**POLK COUNTY, A POLITICAL SUBDIVISION OF
THE STATE OF FLORIDA**

ADDENDUM # 5

**BID # 25-420, Thompson Nursery Road Extension Phase 1 – Segment 1
FPID# Project No. 452355-1-54-01**

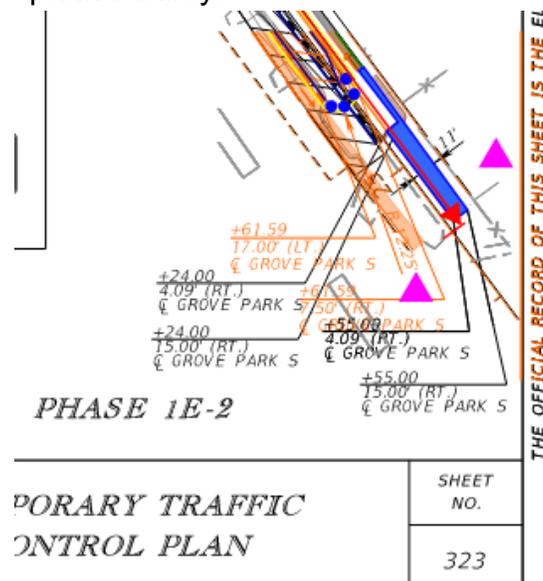
Question 46: There appears to be additional temp pavement installed on Grove Park around station 25+0 in Phase 1E-2 that should probably have been installed in Phase 1E. See attached & please clarify?

Answer 46: Temporary pavement is not required to maintain the existing traffic pattern along Grove Park.
